SURRY POWER STATION, UNIT NO. 1

Amendment No. 90
License No. DPR-32

Amendment No. 89
License No. DPR-37

SAFETY EVALUATION BY THE OFFICE OF NUCLEAR REACTOR REGULATION
RELATED TO AMENDMENT NO. 90 TO FACILITY OPERATING LICENSE NO. DPR-32
AND AMENDMENT NO. 89 TO FACILITY OPERATING LICENSE NO. DPR-37

FIGURE 2.1-1 Reactor Core Thermal & Hydraulic Safety Limits
Three Loop Operation, 100% Flow

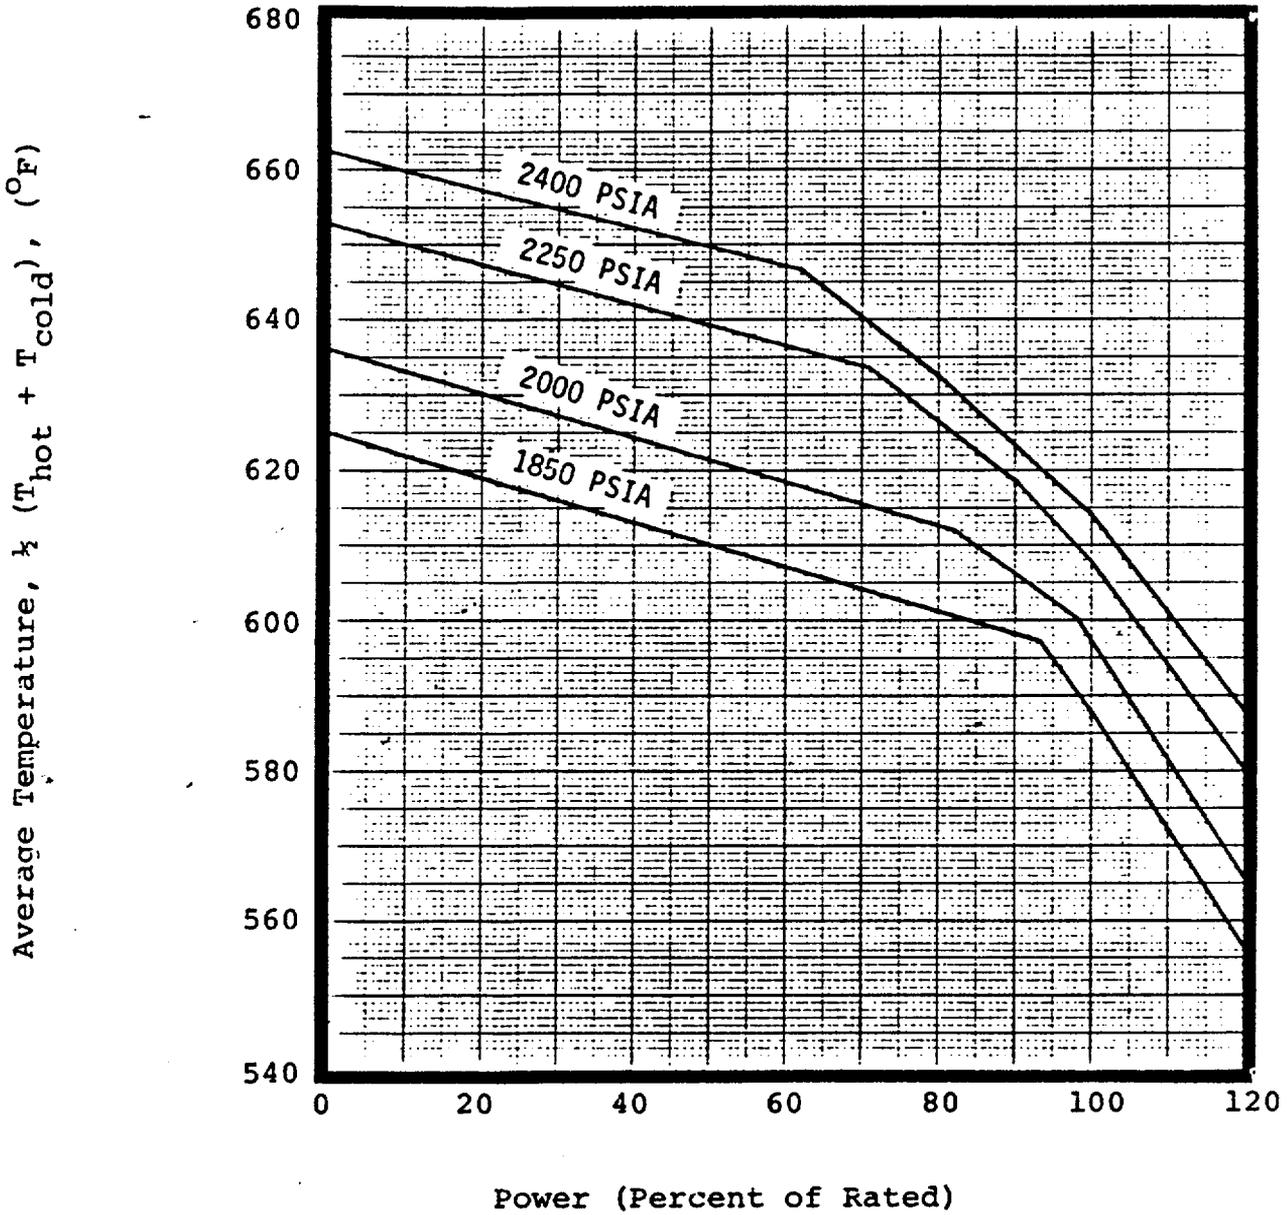
TS Figure 2.1-1 is also valid for the following limit of the enthalpy rise hot channel factor: $F_{\Delta H}^N \approx 1.55 (1 + 0.3 (1-P))$ where P is the fraction of rated power. TS Figures 2.1-2 and 2.1-3 include a 0.2 rather than 0.3 part power multiplier for the enthalpy rise hot channel factor.

Figure 2.3-1 OPΔT and OTΔT f(ΔI) Function

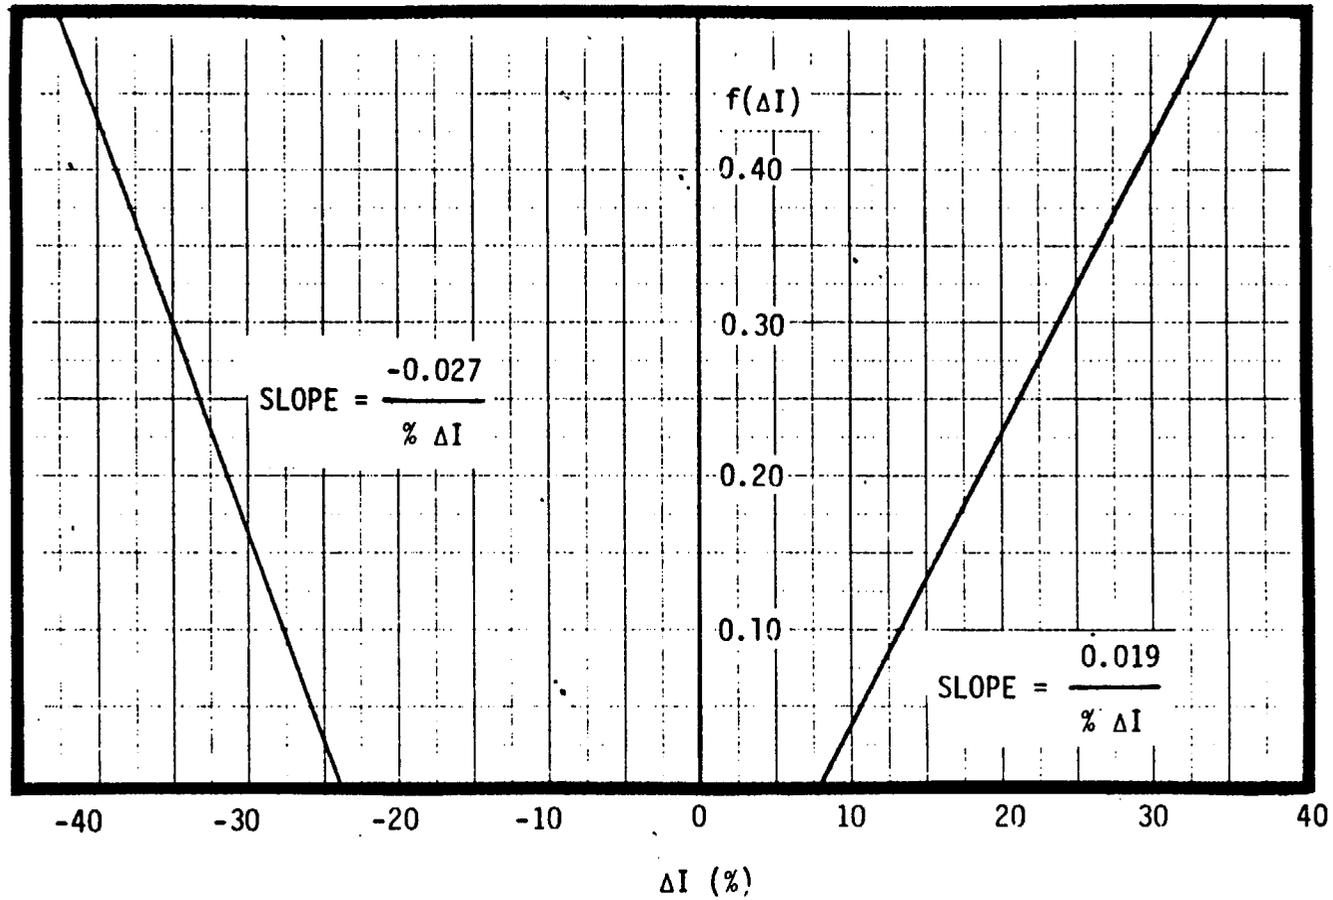
As a result of the multiplier change, small changes to the core thermal limits, overtemperature and overpower ΔT setpoints and the $F(\Delta I)$ function were necessary. The required changes were made to the Technical Specifications.

FIGURE 3.12-1A CONTROL BANK INSERTION LIMITS FOR 3-LOOP NORMAL OPERATION-UNIT 1

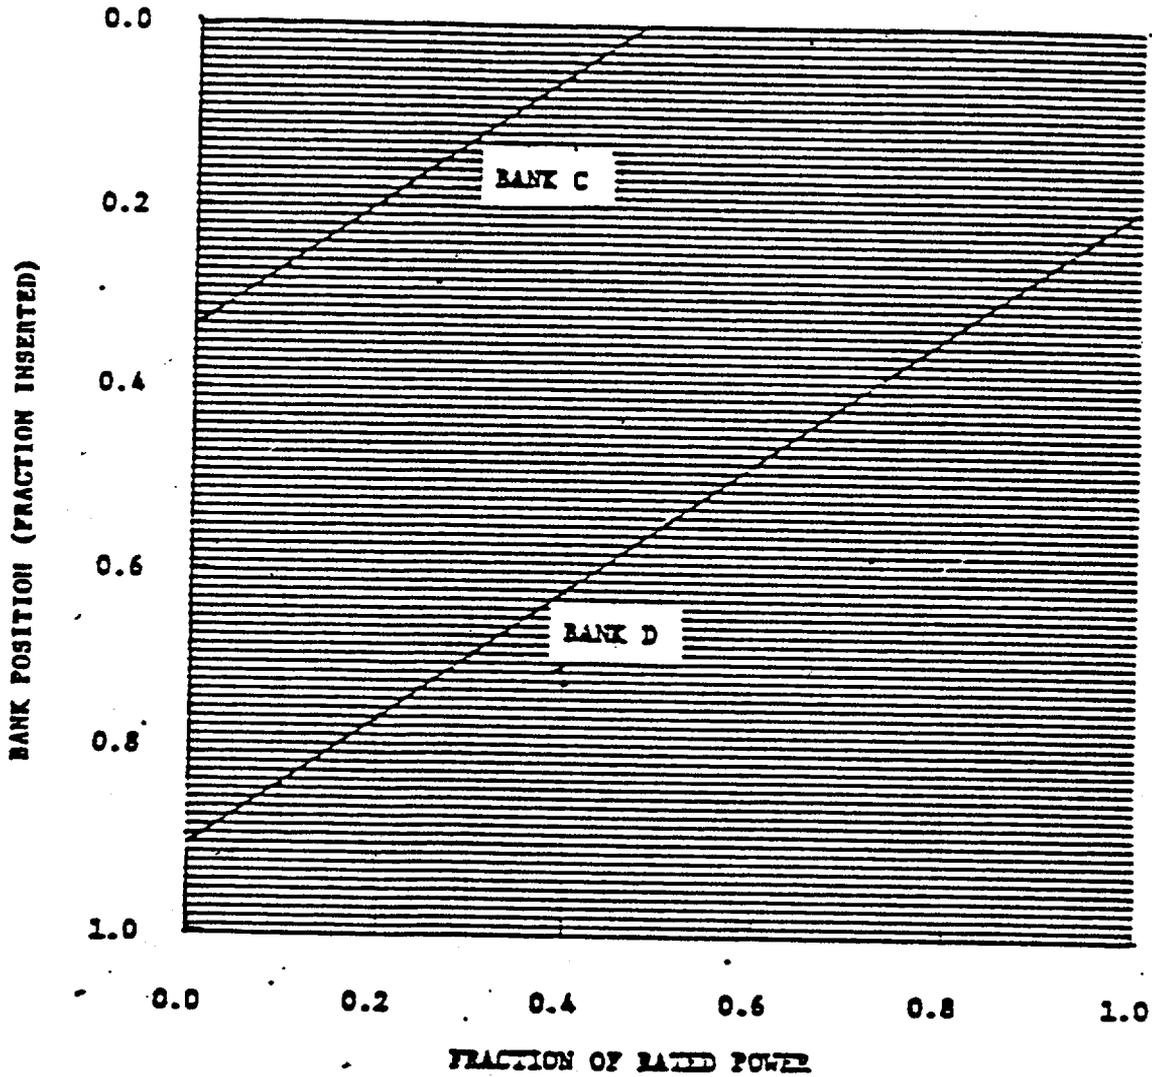
For Cycle 7, the rod insertion limits for Unit 1 were raised from the previously established limits in order to maintain the radial power peaking factors ($F_{\Delta H}^N$) below the Technical Specification limits (i.e., $F_{\Delta H}^N \leq 1.55 (1.0 + 0.2(1-P))$ when P = fraction of rated thermal power). The reload safety evaluation of Unit 1 Cycle 7 established that after 1000 MWD/MTU of Cycle 7 burnup, $F_{\Delta H}^N$ would stay within the limits defined by $F_{\Delta H}^N \leq 1.55 (1.0 + 0.3(1-P))$ with the previously acceptable rod insertion limits. Since the 0.3 partial power multiplier is established, the licensee has requested to change the rod insertion limits back to the previously established limits after 1000 MWD/MTU of Cycle 7 operation. We were aware that the licensee would be proposing this change as soon as the 0.3 partial power multiplier was established and we agree that the change is appropriate. Based on our review we find the rod insertion limit change for Unit 1 to be acceptable after 1000 MWD/MTU of Cycle 7 operation.
